## SPECIAL SERVICE INSTRUCTIONS

### Instructions to correct wiring error on 2075

**SIoux**  
**TOOLS INC.**

REAR VIEW OF CONTROL PANEL  
 AS SEEN FROM FRONT OF MACHINE AFTER REMOVAL  
 (RUSSENBARGER SWITCHES ONLY)

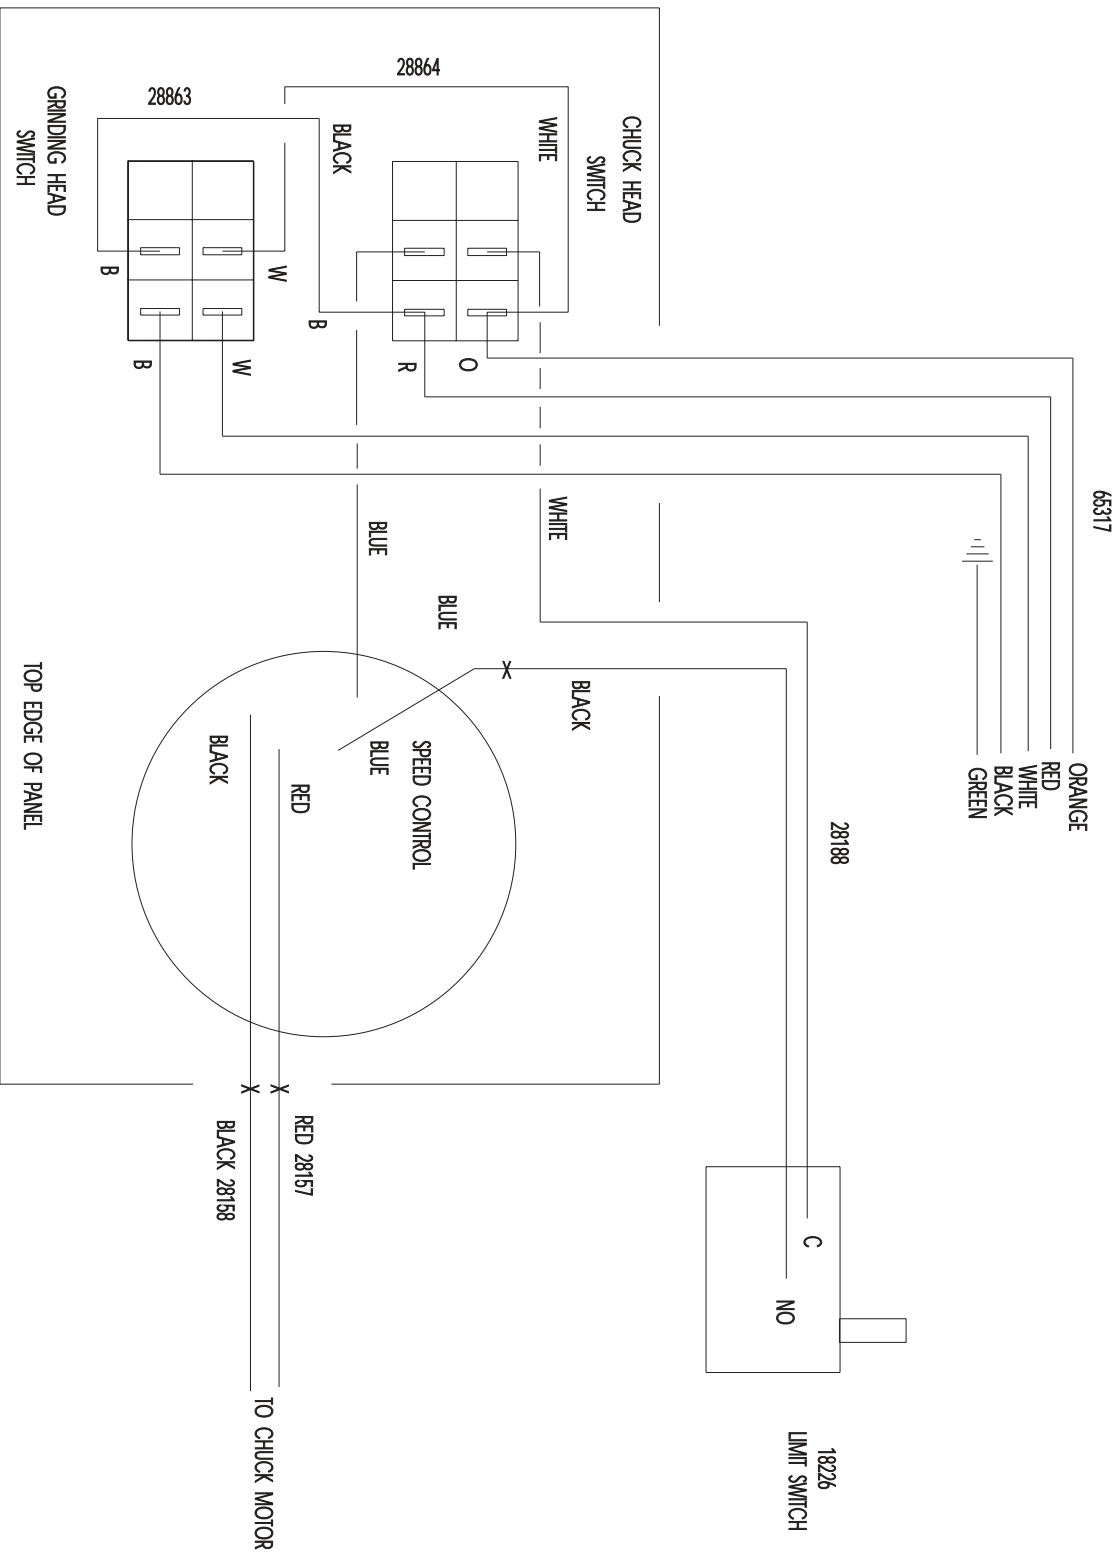
If the grinding head switch is lit when the unit is plugged in, and the grinding head switch is in the off position, the wiring in the chuck head has been assembled incorrectly. The Black and White set and the Red and Orange set of power wires in the 5-conductor cord have been connected incorrectly.

5. Remove the RED and ORANGE wires from the grinding head switch by pulling on the terminals with a needle-nose pliers. This is the top switch, and the terminals closest to the speed control module. Do not pull on the wires themselves or they may come loose from the terminals.

6. Carefully remove the BLACK and WHITE wires from the chuck motor switch. This is the lower switch. These wires are the closest to the speed control, and connected to jumpers of like colors. Do not remove the jumpers, but carefully remove the wires from the jumper using a needle-nose pliers to pull on the terminal.

7. Connect the BLACK wire to the top terminal on the grinding head switch. Connect the WHITE wire to the bottom terminal on the grinding head switch.
8. Connect the RED wire to the BLACK jumper wire on the top terminal of the chuck motor switch. Connect the ORANGE wire to the WHITE jumper wire on the bottom terminal of the chuck motor switch.
